Access Compliance Report

Public Rights-of-Way

(Curb Ramps)

Intersection ID: 10034320	Main Street: PERIMETER_PY	Cross Street: N/A	Location: NW
ADA ID: 1B2A022D7125	Ramp Type: Perp	Initial Pass/Fail: Fail	Overall Compliance: No
Severity Score: 10			
Codes/Mitigation Info/Possible Solution		Field Measurements/Component Compliance

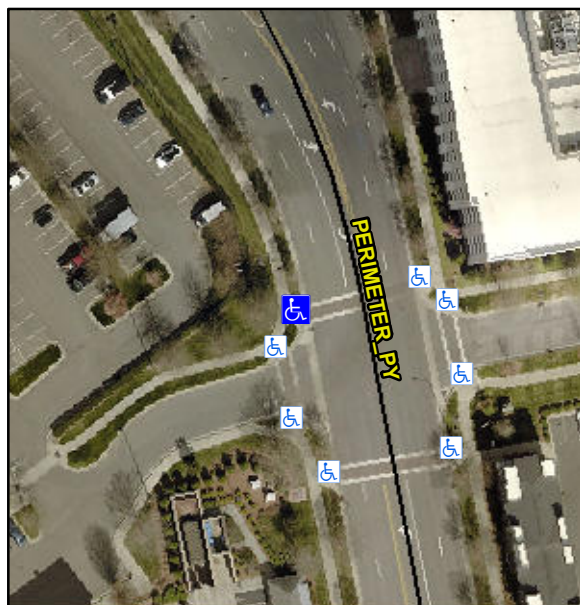
Not Found, R304.5.1, R304.5.3

Compliance	Description	Data	Compliance	Description	Data
N/A	Ramp Length (in)	46.0	Yes	Ramp Slope (%)	7.4
No	Ramp Width (in)	47.0	No	Ramp XSlope (%)	2.2
N/A	Flare Type LT	N/A	N/A	Flare Type RT	N/A
N/A	Flare Slope LT (%)	N/A	N/A	Flare Slope RT (%)	N/A
N/A	Flare Traversable LT?	N/A	N/A	Flare Traversable RT?	N/A
N/A	Landing Length (in)	N/A	N/A	DWS Provided?	N/A
N/A	Landing Width (in)	N/A	N/A	DWS Contrast?	N/A
N/A	Landing Slope (%)	N/A	N/A	DWS Length (in)	N/A
N/A	Landing X Slope (%)	N/A	N/A	DWS Full Width?	N/A
N/A	Landing Curb? (Y/N)	N/A	N/A	DWS Offset (in)	N/A
N/A	Shared Landing?	N/A			
N/A	Gutter Ponding?	N/A	N/A	Gutter Slope (%)	N/A
N/A	Gutter Lip Ht (in)	N/A	N/A	Gutter X Slope (%)	N/A
N/A	Painted X Walk1?	Yes	N/A	Painted X Walk2?	N/A
	X Walk 1 Direction	To E		X Walk 2 Direction	N/A
N/A	X Walk 1 Width (in)	72.0	N/A	X Walk 2 Width (in)	N/A
	X Walk 1 Slope (%)	4.1		X Walk 2 Slope (%)	N/A
	X Walk 1 X Slope (%)	2.1		X Walk 2 X Slope (%)	N/A

Remove & Replace Entire Ramp.
